PG&E Letter DIL-24-004

Docket No. 72-26, Materials License No. SNM-2511
Diablo Canyon Independent Spent Fuel Storage Installation
Responses to NRC Requests for Additional Information on the Diablo Canyon Independent
Spent Fuel Storage Installation License Renewal Application (CAC/EPID NOS. 001028/L-
2022-RNW-0007)

**Pacific Gas and Electric Company Responses to Requests for Additional Information
for the Technical Review of the Application for Renewal of the Diablo Canyon
Independent Spent Fuel Storage Installation**

**Diablo Canyon Independent Spent Fuel Storage Installation
Site-Specific License Renewal Application, Revision 3**

Figure F3.8-1 Sensitive Wildlife Resources at Diablo Canyon Power Plant

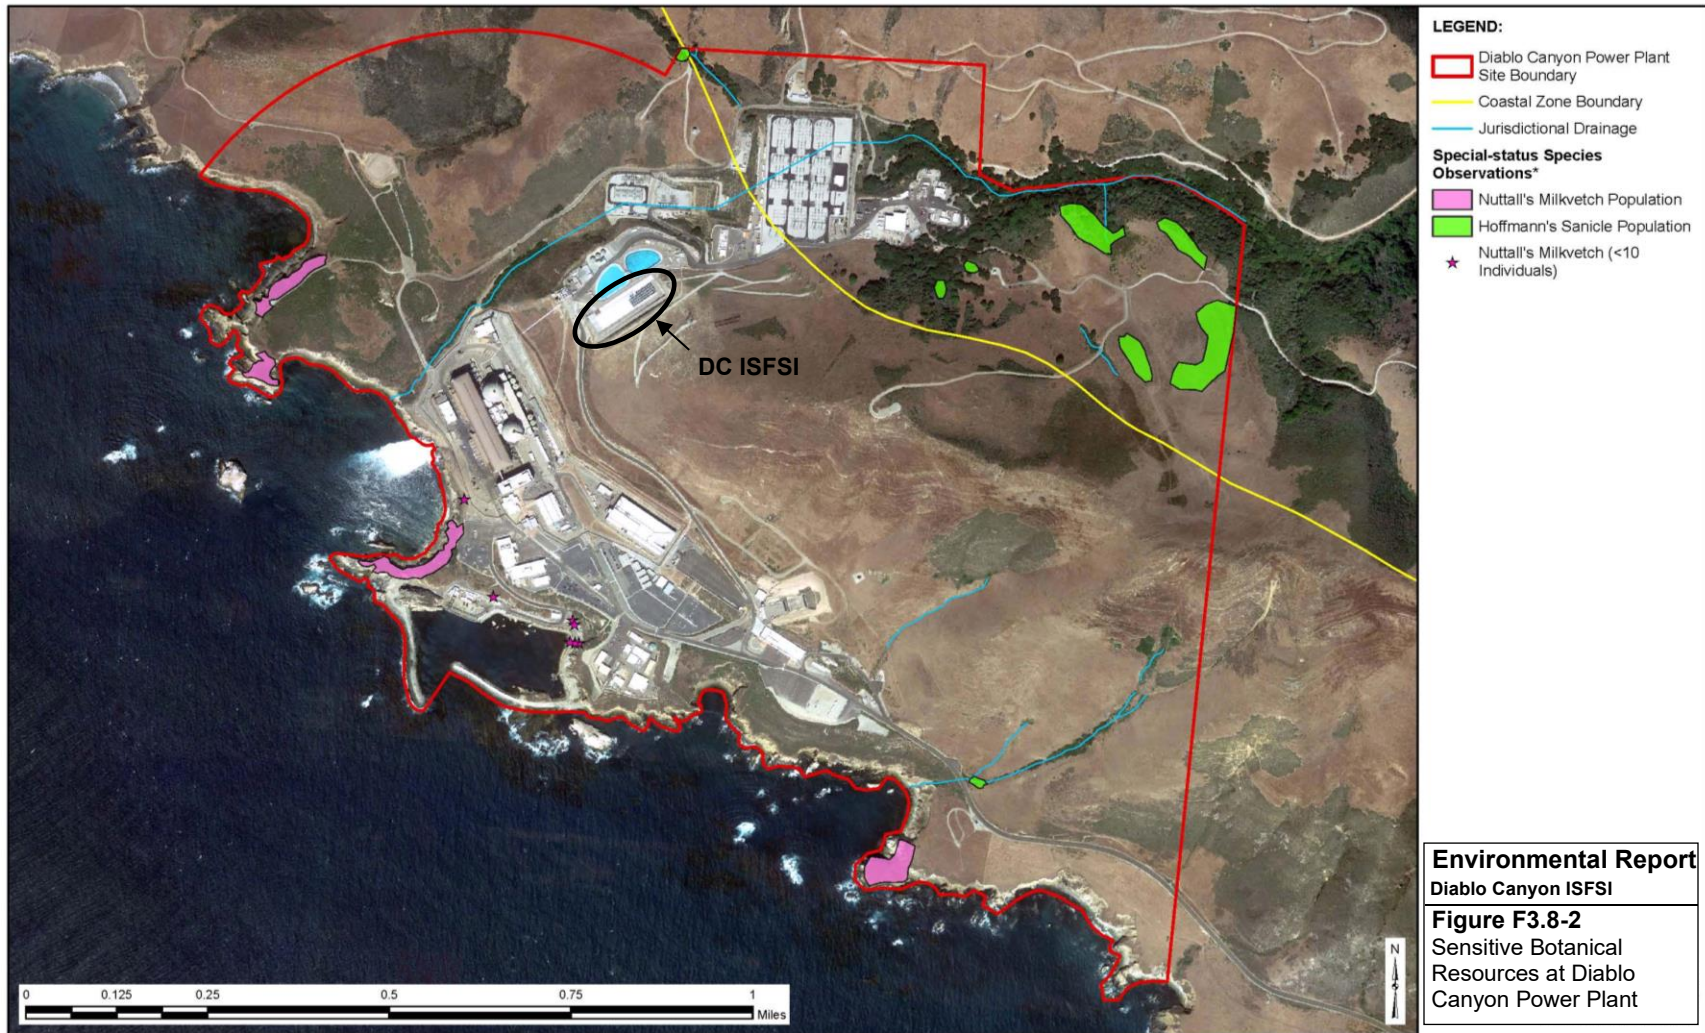
On September 21, 2023, PG&E submitted their response (ML23264A859) to the NRC's request for additional information (RAI) (ML23159A238). Figure 3.8-1 "Sensitive Wildlife Resources at Diablo Canyon Power Plant," in Appendix F, Environmental Report Supplement, of the ISFSI license renewal RAI response indicates that the California red-legged frog occurs at the Diablo Canyon Creek in close proximity to the ISFSI site. Section F3.8 in Appendix F, Environmental Report Supplement, references the Permit Application Package for the Diablo Canyon Power Plant Decommissioning Project with the County of San Luis Obispo (PG&E 2021). The permit application package cites the biological survey performed by Terra Verde, which indicates the presence of the California red-legged frog at the Diablo Canyon Creek. The biological survey concludes that impacts from the decommissioning project on the California red-legged frog would be low due to the low population observed.

LRA, Sections F3.8 and F4.3 are revised in Enclosure 2 to provide additional information related to the California red-legged frog (CRLF; *Rana draytonii*). In support of Diablo Canyon Power Plant (DCPP) decommissioning and DCPP LR, PG&E has been in communication with the United States Fish and Wildlife Service (USFWS) regarding CRLF at the DCPP property. PG&E has had several meetings with staff from the Ventura USFWS Office. In particular, PG&E staff attended an in-person meeting with USFWS Section 7 Coordinator Mark Elvin on June 30, 2023, and follow-up discussion on August 7, 2023, to discuss the Federal Endangered Species Act (ESA) Section 7 consultation required for DCPP decommissioning. These meetings included focused discussions on activities potentially affecting CRLF, what constitutes suitable CRLF habitat on the DCPP site, and the scope of the Section 7 effects analysis. During these correspondences (and later verified via email), the USFWS provided clear direction on what constitutes CRLF habitat subject to ESA analysis for the DCPP site. Additionally, the USFWS clarified that direct impacts (e.g., ground disturbing activities) within potentially suitable, non-developed upland habitat areas within a 2-mile dispersal range from occupied aquatic habitat are used as a surrogate for take of CRLF individuals for the purposes of Section 7 consultation.
